NOTICE OF AN APPLICATION FOR A TEMPORARY WATER USE PERMIT

APPLICATION NO. 13817

Project	<u>Chambers Creek Watershed: Floodwater Retarding Structure 10</u>	Project Number
Owner	<u>Ellis-Prairie Soil and Water Conservation District</u>	<u>EP-CHAM10-RHB-FED-004-21</u>
Contractor	<u>Granite Construction, Inc.</u>	<u>1137446</u>
Construction Manager	<u>USDA-NRCS</u>	
Design Professional	<u>Freese and Nichols, Inc.</u>

Document No. RD-001 Description Diverting Surface Water Plan & Dewatering the Construction Site Plan

Water Diversion Plan

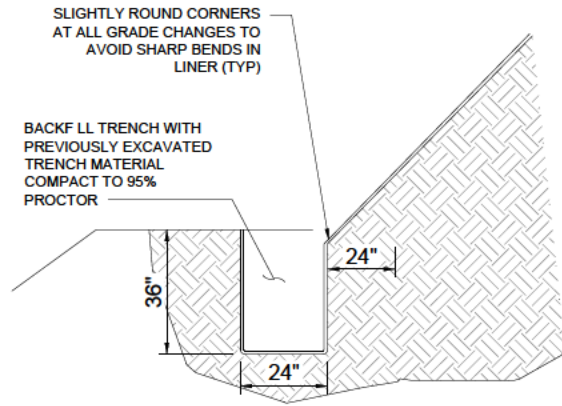
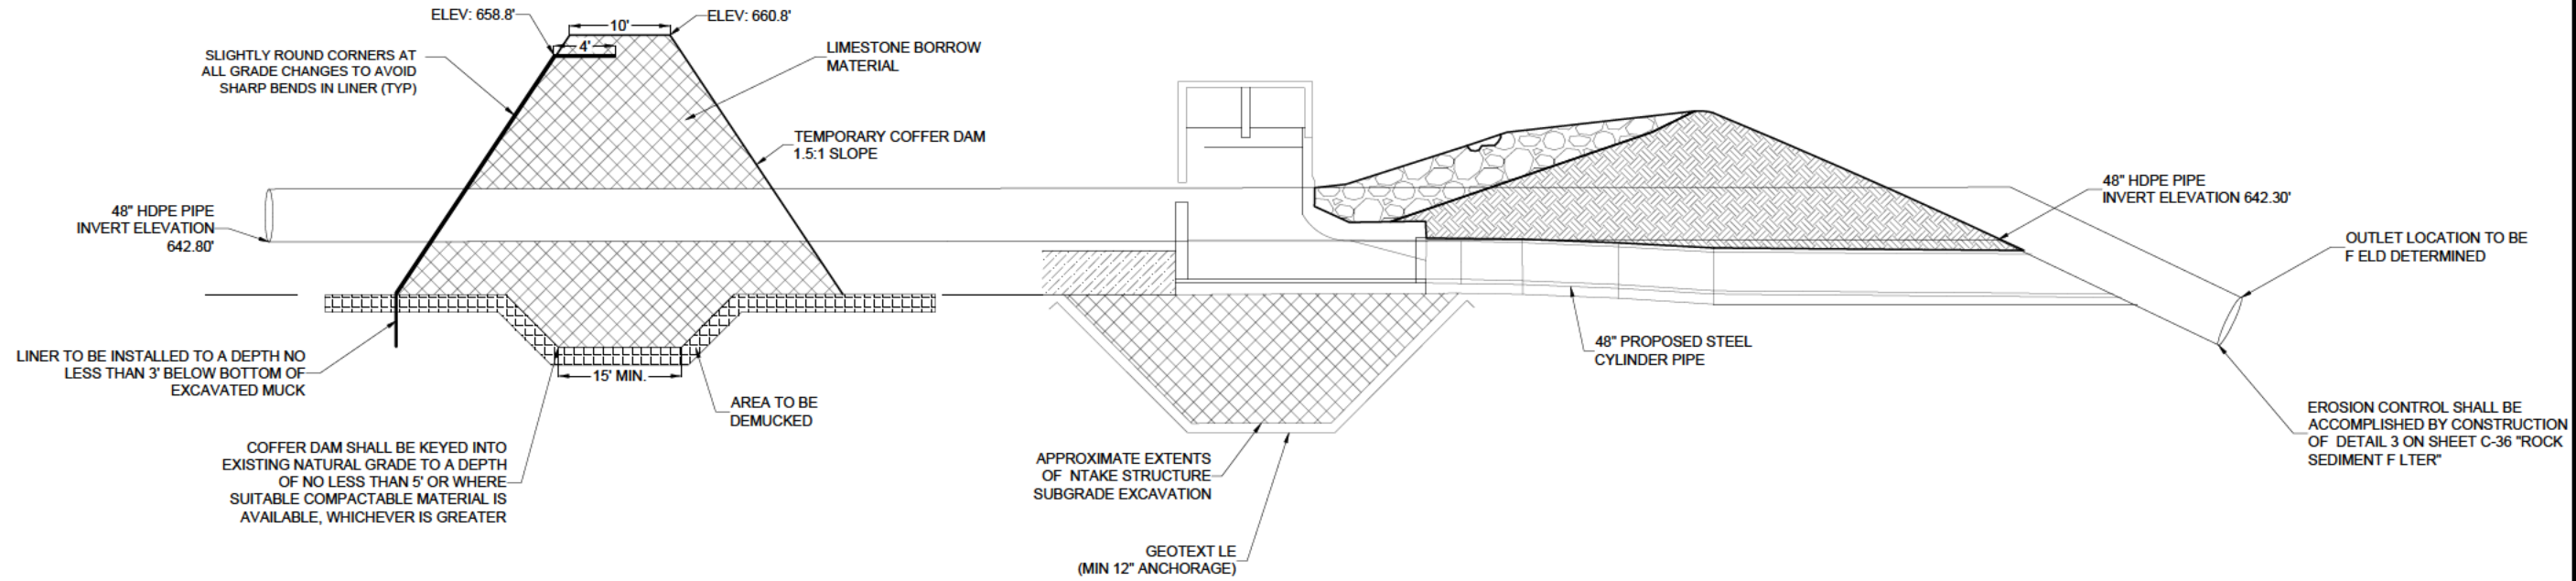
Number	By	Comment
1	USDA - NRCS	<p><u>Water Diversion Plan, Cofferdam Construction, Step 2:</u> This step discusses placing density controlled earthen fill only, and not the limestone as well; Also it only discusses compaction for earthen fill, without addressing the limestone material as well.</p> <p>ANS: Construction Specification 23 – Earthfill states, “Earthfill is composed of natural earth materials that can be placed and compacted by construction equipment operated in a conventional manner.” The density controlled earthen fill material mentioned in Step 2 is the limestone borrow material called out on Sheet 1 of 4 of the coffer dam detail exhibits. The limestone material will be compacted to 95% of the standard proctor density.</p>
2	USDA - NRCS	<p>Will placement and compaction meet the requirements of CS 23? If so this needs to be addressed?</p> <p>ANS: Yes, placement and compaction will meet the requirement of CS 23. The limestone material will be compacted to 95% of the standard proctor density and 0% to +3% optimum moisture. The contractor will utilize dozer rippers and/or excavator bucket teeth for moisture conditioning of the limestone material and scarification of lifts. A disk can not be used in these instances due to the use of limestone rock for coffer dam construction.</p>

3	USDA - NRCS	<p>How will water be sealed off around the pipe and kept from seeping through the cofferdam, if the 48” pipe will be puncturing the liner by going through the cofferdam?</p> <p>ANS: A boot (as shown below) will be used to seal the cofferdam where the 48” pipe penetrates the liner.</p>  <p>Illustration of pipe boot detail—A pipe boot was constructed from an additional piece of geomembrane liner.</p>
